**SANITARY WARE SPECIFICATION SHEET**

**Approval of “KITA” Shower Mixer  
(General Acceptance No. C20210110)**

**General Acceptance No. C20210110**

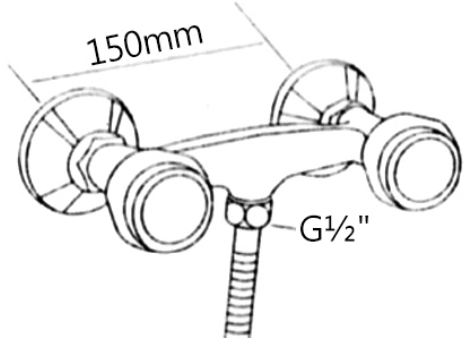
Having considered the test report ref. J25763 issued on 2 December 2020 by Nutek Systems (HK) Ltd., this Authority accepts that the fitting described below complies with, and its use when correctly installed does not contravene, the Waterworks Ordinance and Regulations.

This Authority hereby permits the use of the above fitting in fresh water plumbing systems subject to full adherence to Waterworks installation requirements. In particular, you are required to draw your customers' attention to the following requirement-

"The cold water supply to the fitting shall be drawn from the same source that supplies the hot water apparatus so as to provide a balanced pressure and to obviate the risk of scalding in the event of a restriction or failure in the water supply." AND

"The shower head or handspray should not be placed in submerged conditions and should be securely fixed to the original position after use."

A condition of this acceptance is that the fitting to be installed shall be replicas of the sample as certified by the testing agent mentioned above and without modifications. This acceptance may be withdrawn at any time if the standard of the fitting installed fails to meet that of the approved sample or if the fitting is found to be unsuitable for use in fresh water plumbing systems.

This acceptance is only applicable to the main body of the fitting, unless otherwise specified.
